IPSC COMMENTS ON
DRAFT REPORT ARE
ENCLOSED.

**Coal Burner Condition and
Estimated Remaining Life Evaluation
- IPP Units #1 & 2**

Final Report

Intermountain Power Services Corporation

Figure 1
2-2

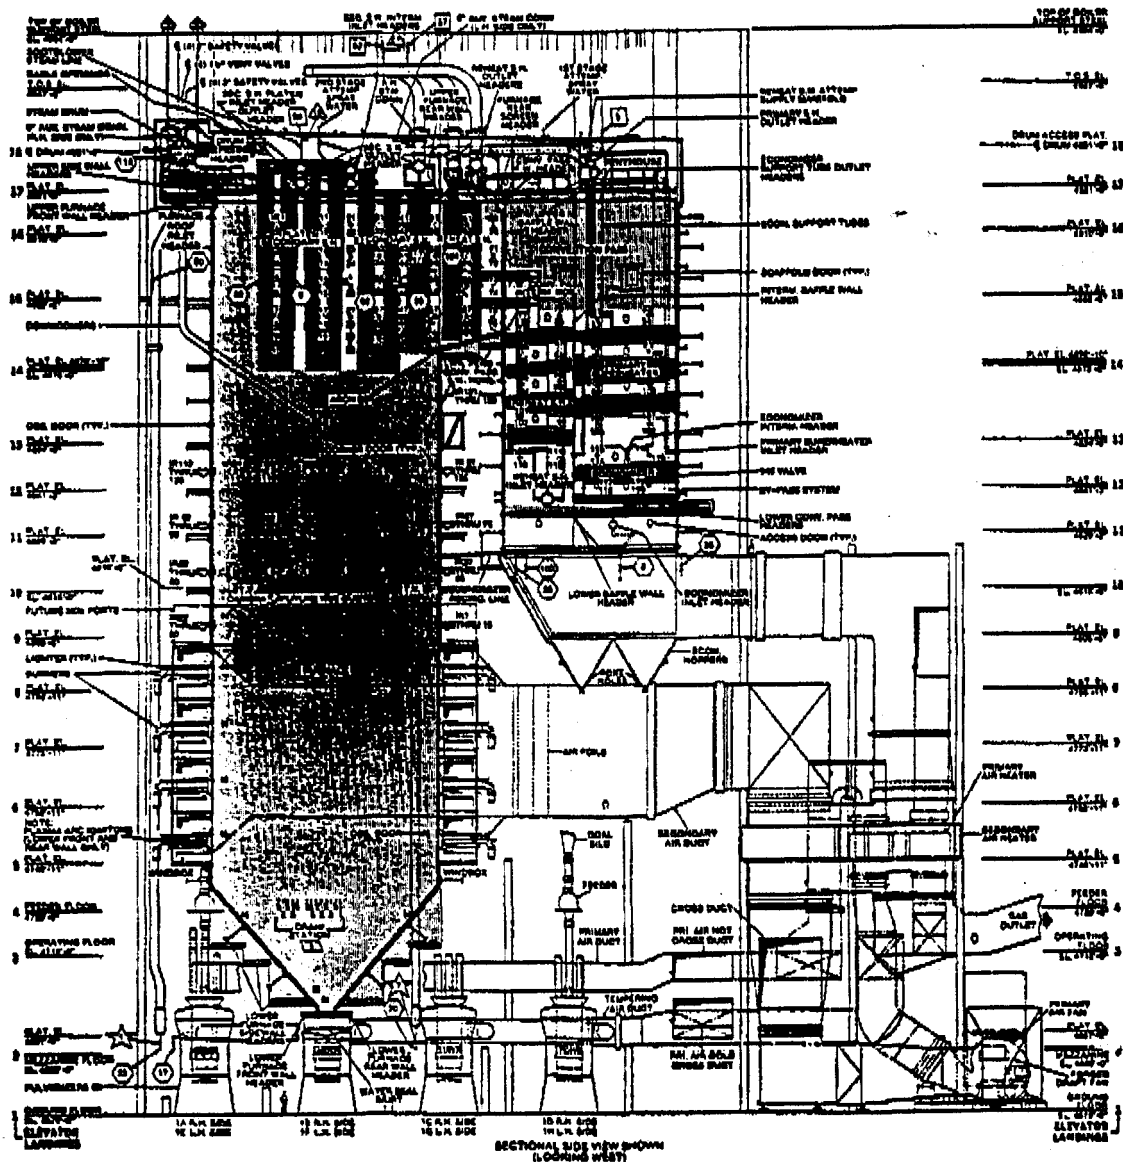
Intermountain ~~Power Project~~ Units #1 & 2 are indoor, balanced draft, parallel back-end, Carolina Type Radiant Boilers provided by the Babcock & Wilcox Company. Each unit ~~will~~ fire pulverized coal from forty-eight high input dual-register burners arranged in four rows of six burners on both the front and rear furnace walls. The burner windboxes are compartmented with air dampers located on each end. Furnace dimensions are 85 ft wide, 60 ft deep, and 299.5 ft from the lower wall header centerline to the drum centerline. Figure 1 illustrates the general ^{BOILER} arrangement of these units. ^{WHAT DOES THIS MEAN?}

Figure 4

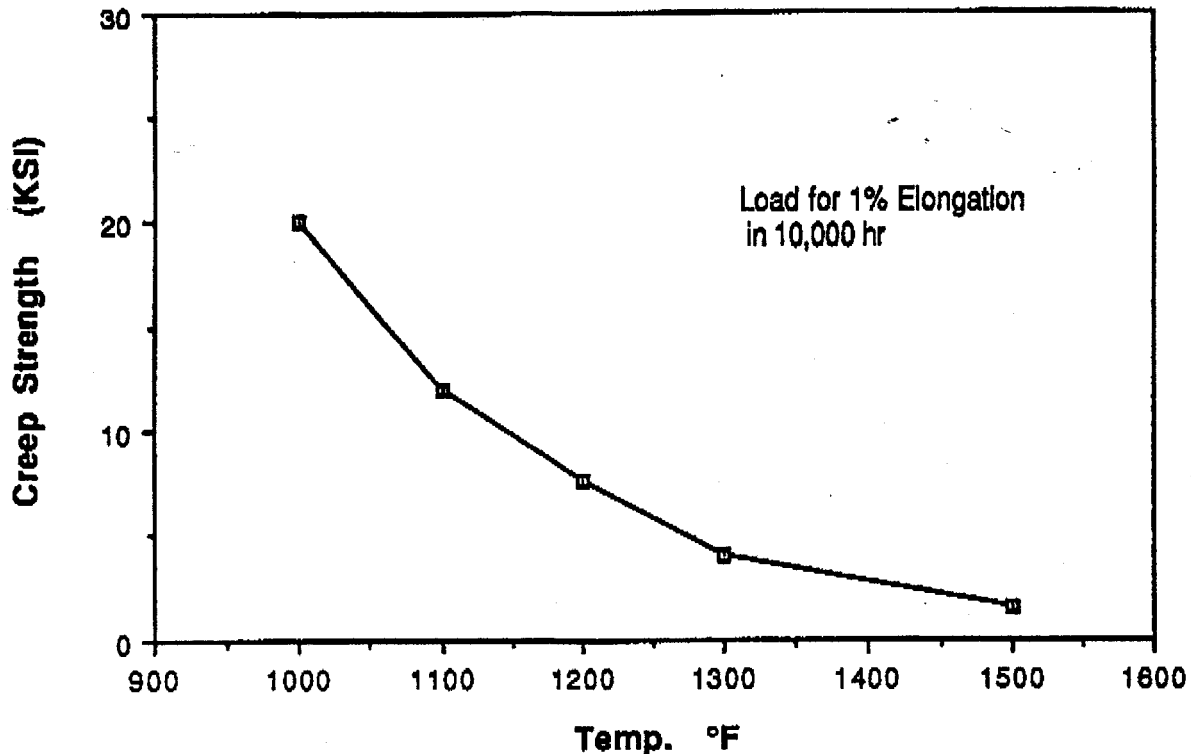
QUANTIFIABLE? REFERENCES?
